Planning Commission Issues Report

Subject: Change of Zoning Issues Report

Petition: P.Z. 01 & 02-2013 Arbors at Kehrs Mill (17015 Church Rd.).

Arbors at Kehrs Mill
 Chesterfield, Missouri
 PRELIMINARY PLAN

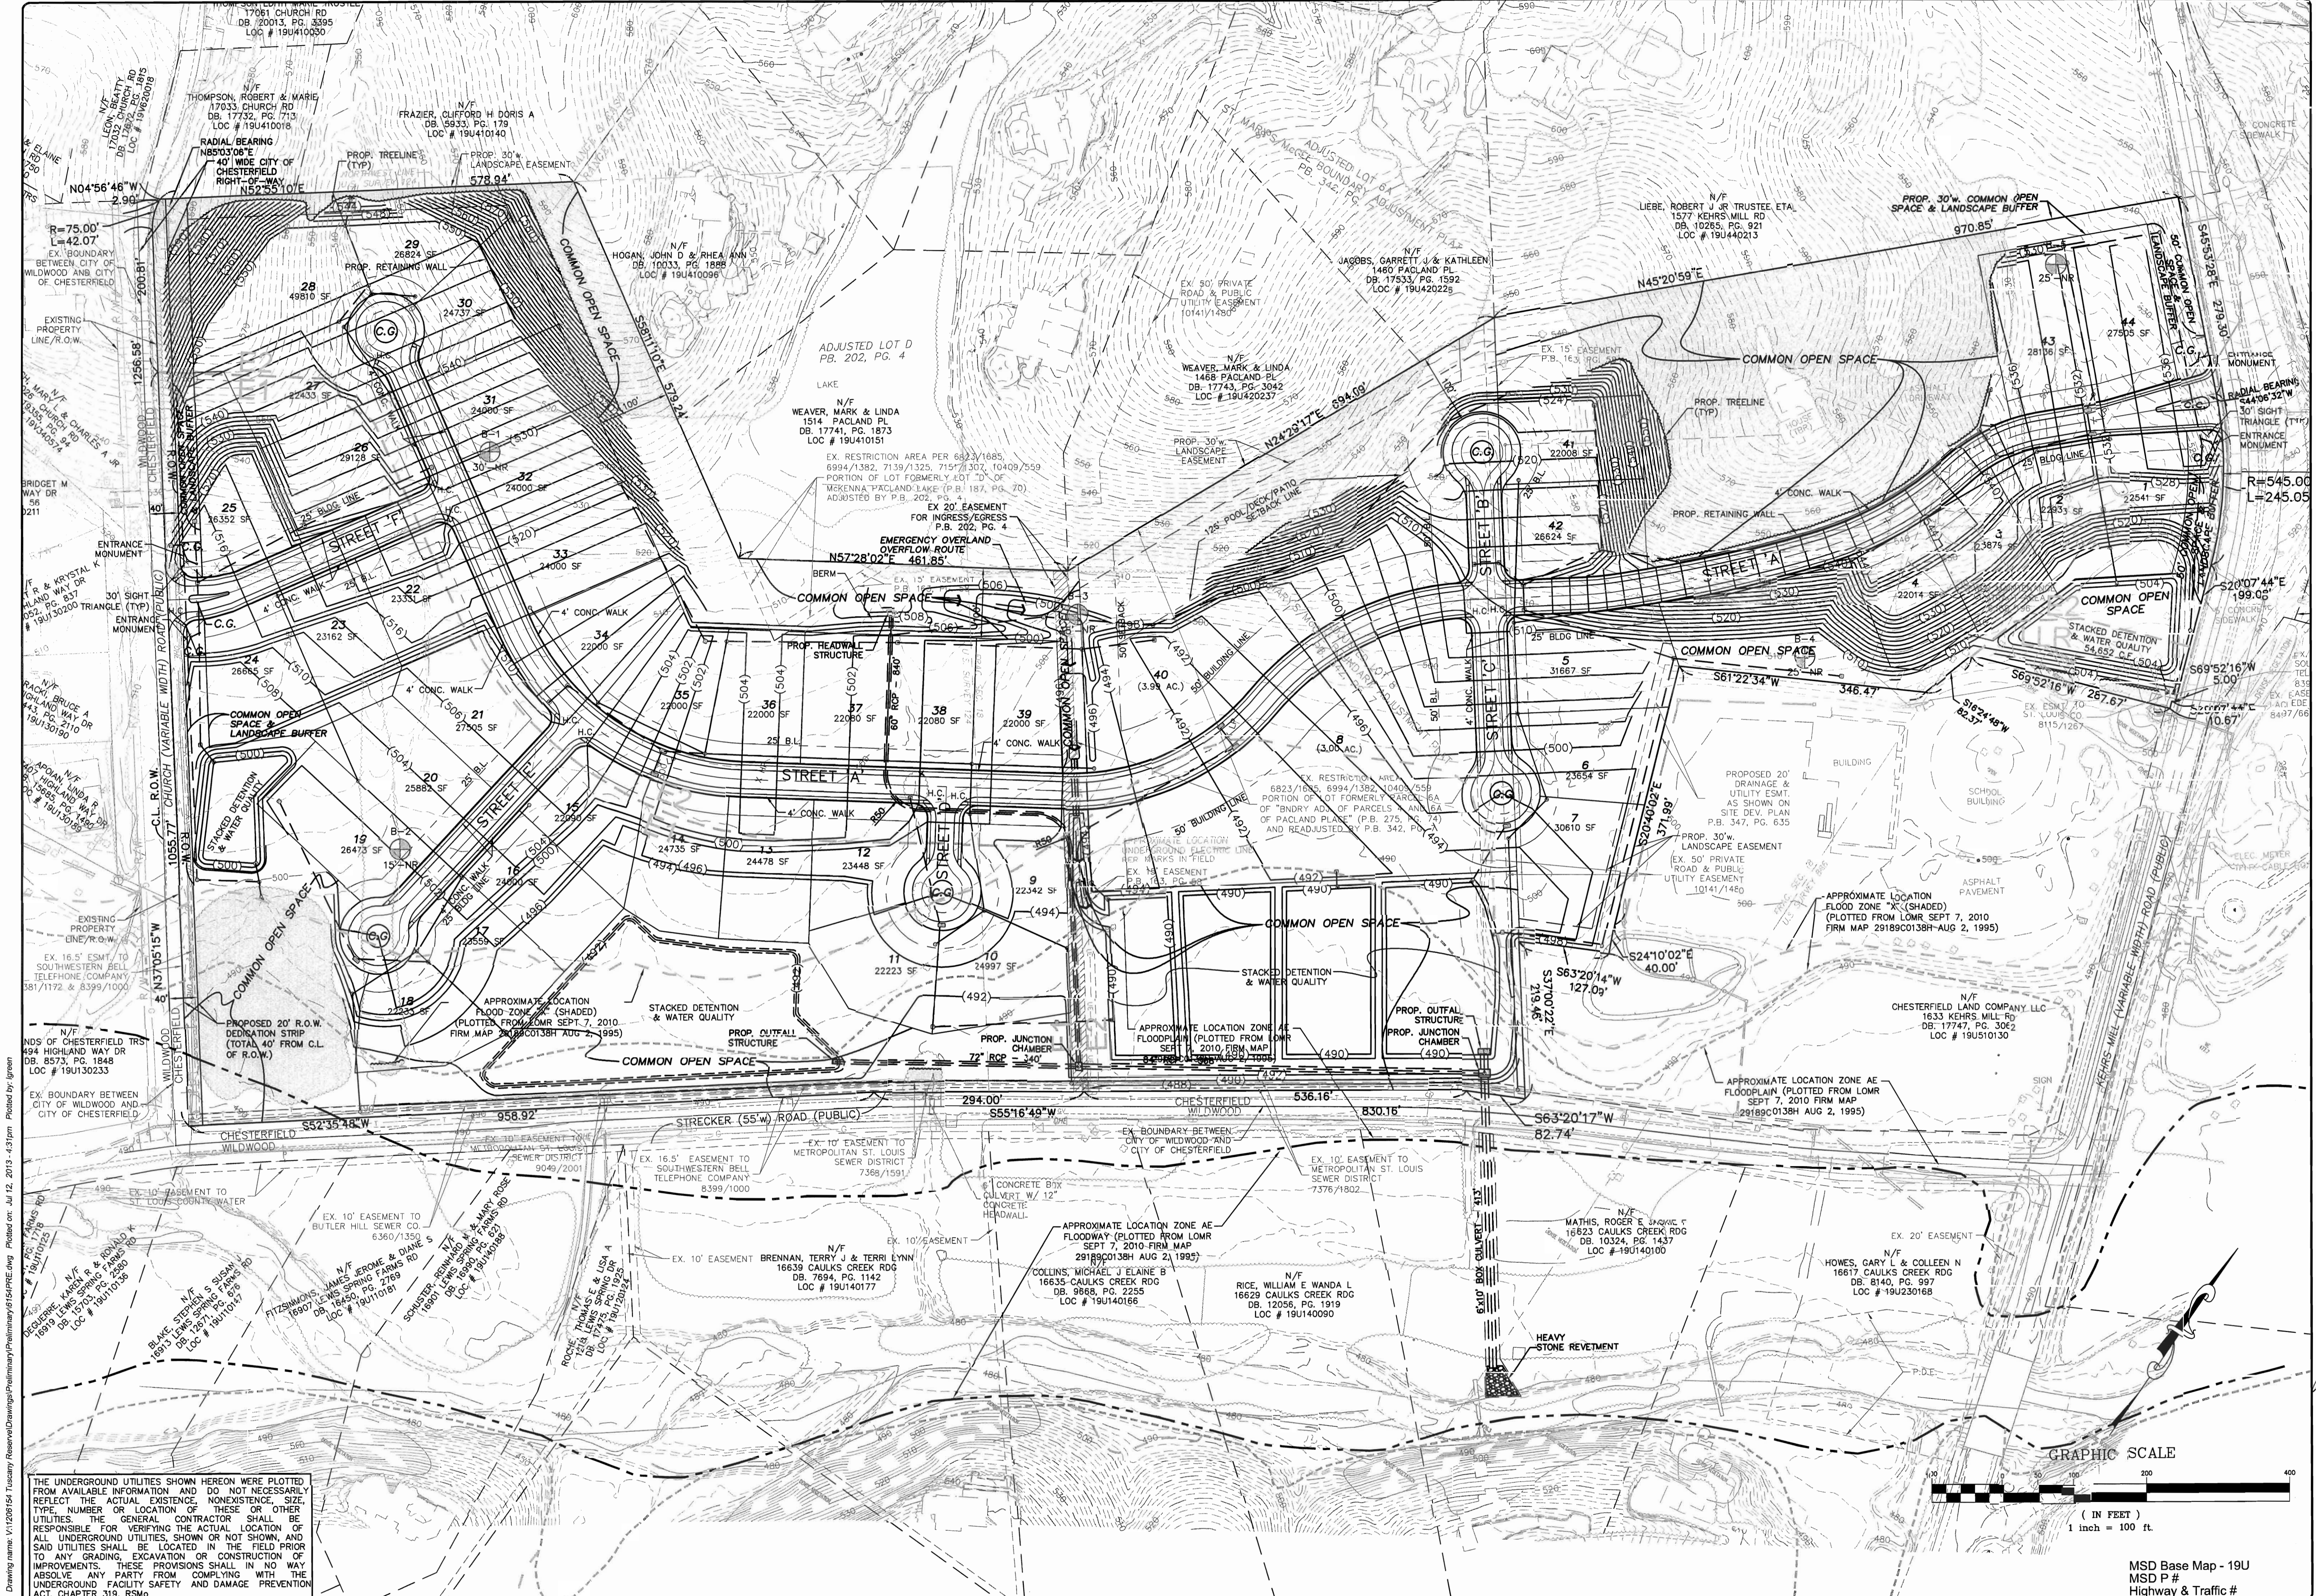
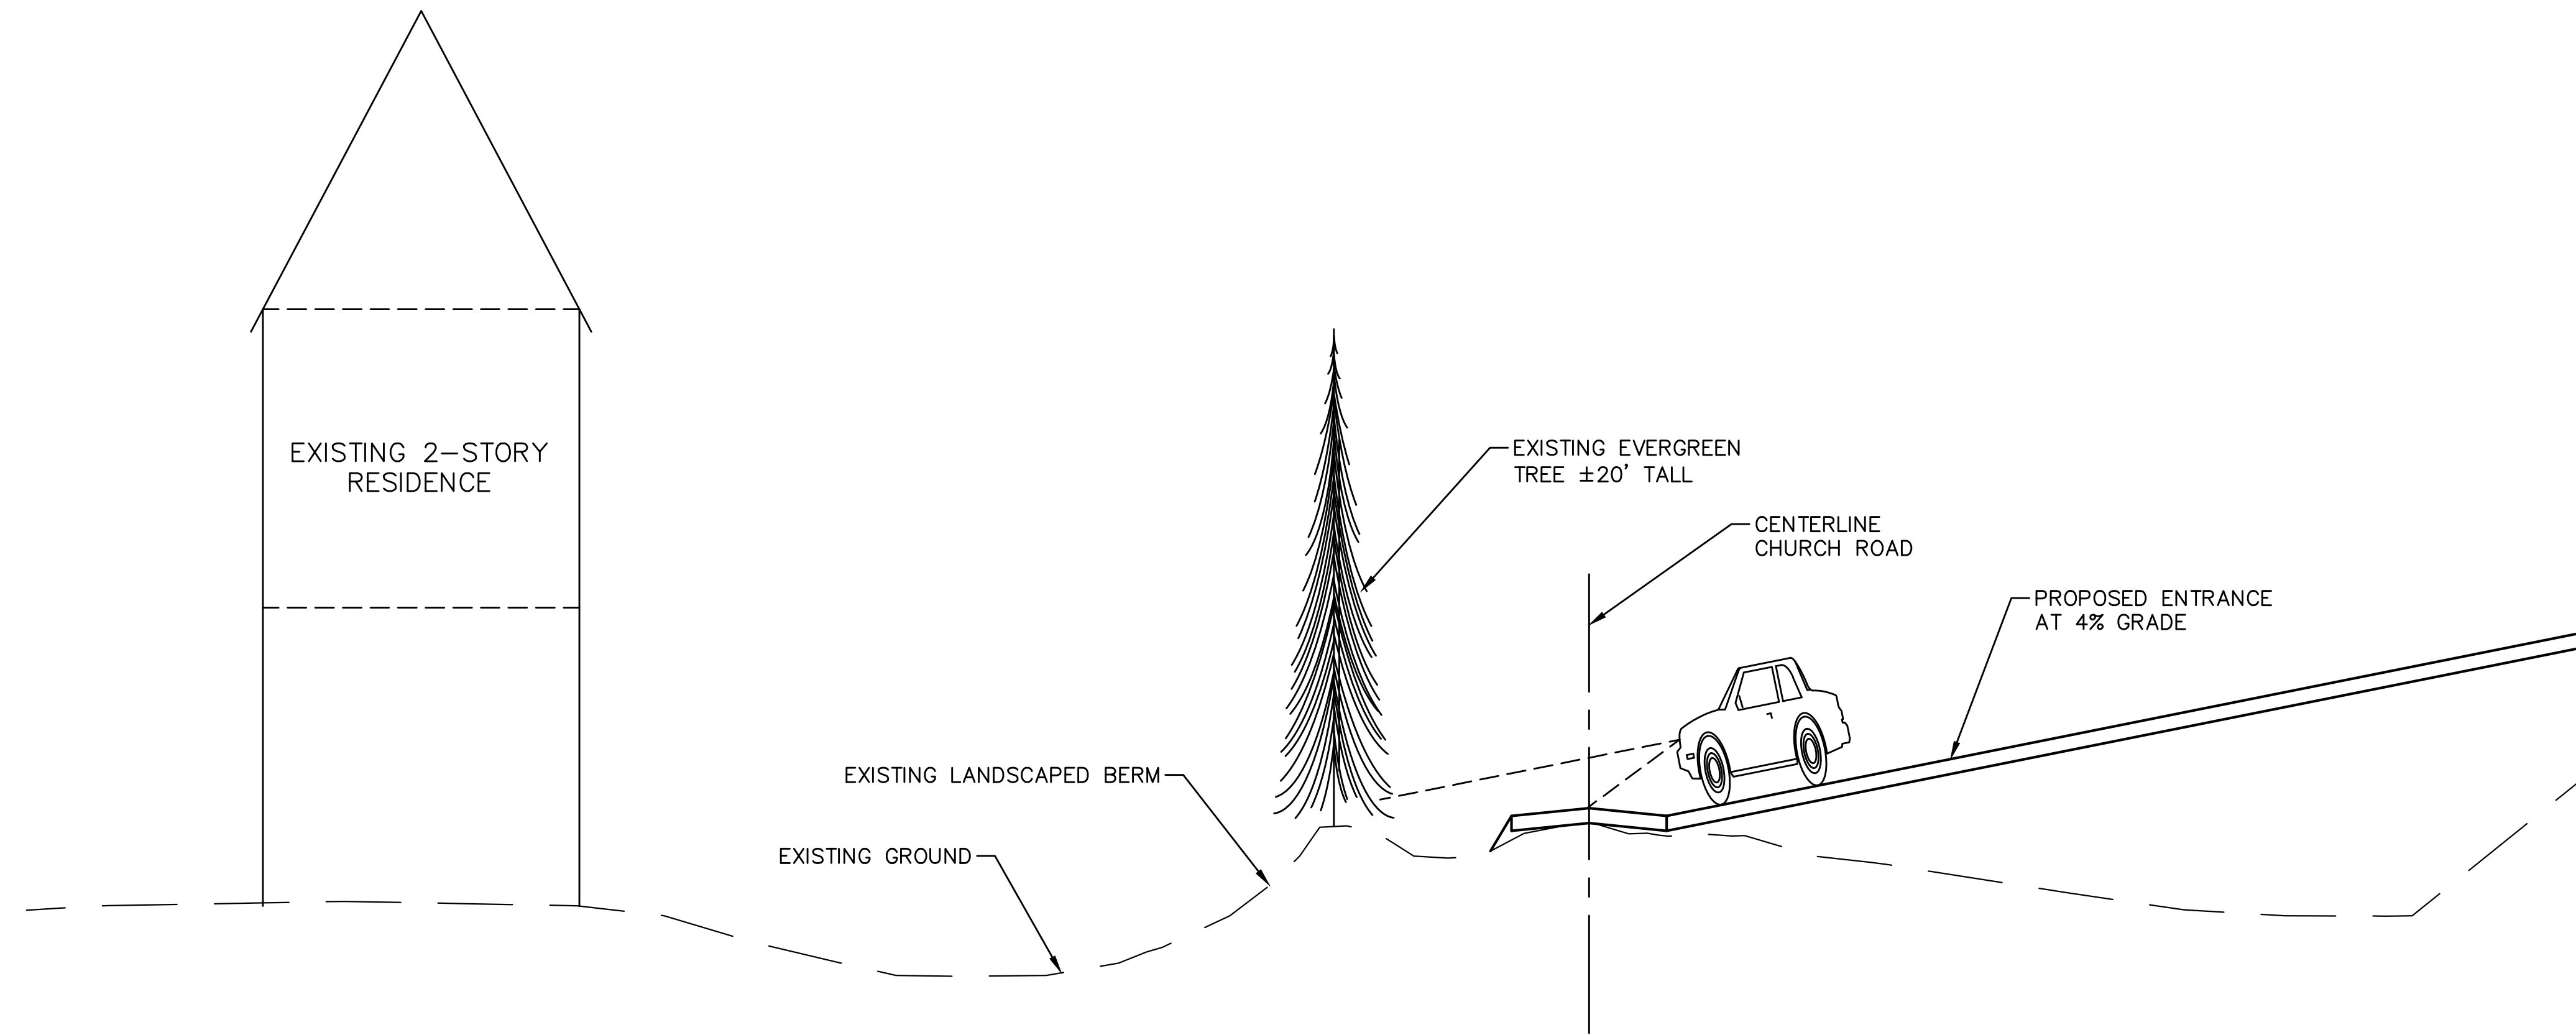
1. 30% Open Space: The Preliminary Plan has been revised to depict deduction of the area for the entry monuments in the calculation of the open space percentage.

3. Depict full Existing Easements: The Preliminary Plan has been revised with clear notes depicting these easements.
4. Slopes: The actual and final slope calculations will be done concurrent with the preparation of the improvement plans. We understand that approval of the zoning and Preliminary Plan does not constitute approval of slopes.

6. Church Road Dedication: The portion of Church road located within the City of Chesterfield will be 40' wide after the approximately 20' right-of-way dedication that we will be granting along with this project. This right-of-way and dedication is accurately depicted on the enclosed revised Preliminary Plan.
